6.0 COMMENT SUMMARY AND RESPONSE TO THE SDEIS

In this chapter, the Section of Environmental Analysis (SEA) responds to the comments on the Supplemental Draft Environmental Impact Statement (SDEIS).

**Figure 6-1
Castroville
West**

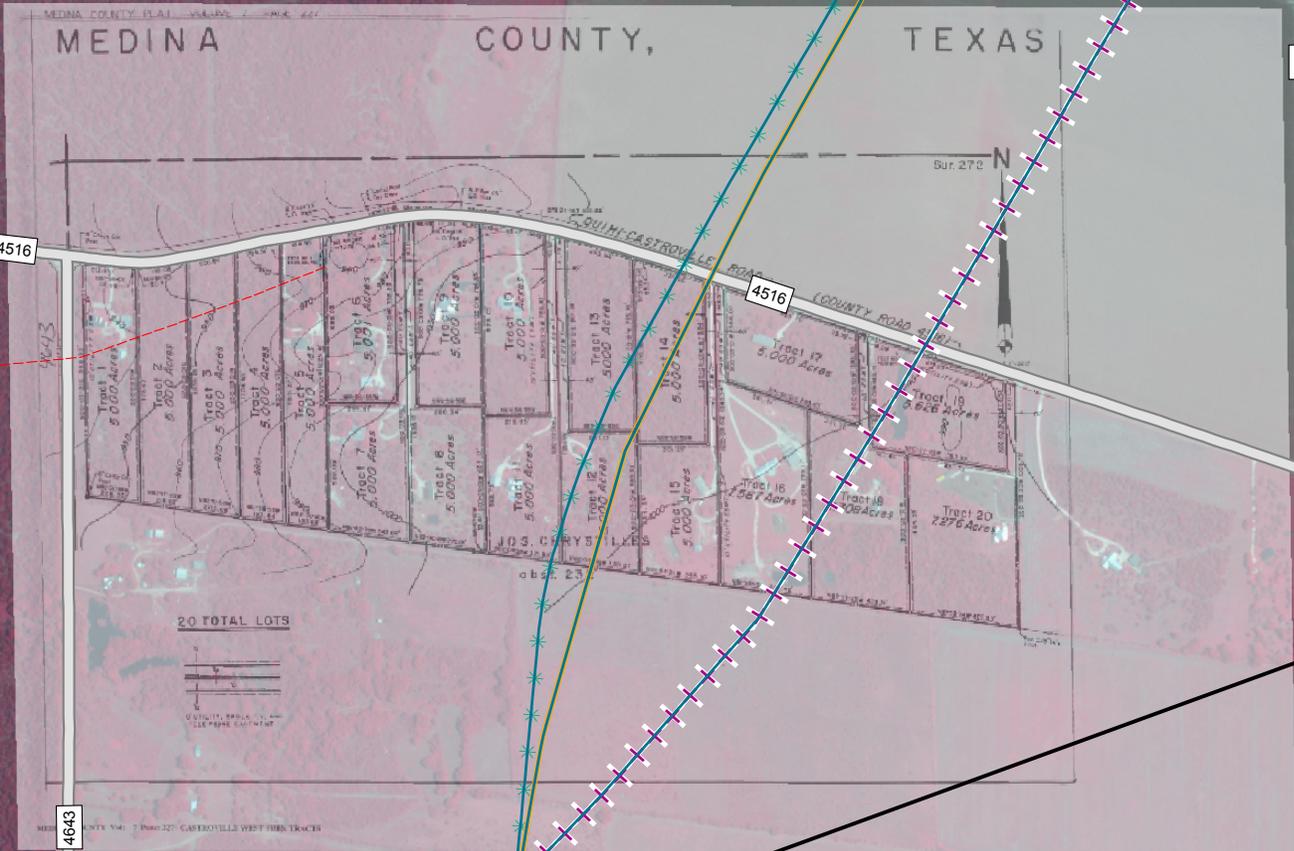
Response: Comment noted. A modification of the Eastern Bypass Route (called the Modified Eastern Bypass Route) was evaluated in this FEIS and is included as part of the two environmentally preferable routes that SEA is recommending. This modification would limit impacts, to the extent practicable based upon topography, on the Weiblen property and the Castroville West Subdivision by routing the new line as close as possible to property lines.

Response: To respond to this comment, SEA overlaid the Castroville West Subdivision boundaries over the rail line alignments being considered in this proceeding (see Figure 6-1 of this FEIS). All three Eastern Alternatives would cross this restricted subdivision. To respond to several concerns from the public, SEA analyzed the Modified Eastern Bypass Route (a modification of the Eastern Bypass Route) in this FEIS. This modification would not only limit impacts, to the extent practicable based upon topography, on the Weiblen property by routing as close as possible to property lines, but also would avoid the Castroville West Subdivision.

Response: To respond to this comment, SEA overlaid the Castroville West Subdivision boundaries over the rail line alignments being considered in this proceeding (see Figure 6-1). All three Eastern Alternatives would cross this restricted subdivision. To respond to several concerns from the public, SEA analyzed a modification of the Eastern Bypass Route in this FEIS, which would limit impacts, to the extent practicable based upon topography, on the Weiblen property by routing the rail line as close as possible to property lines, and would avoid the Castroville West
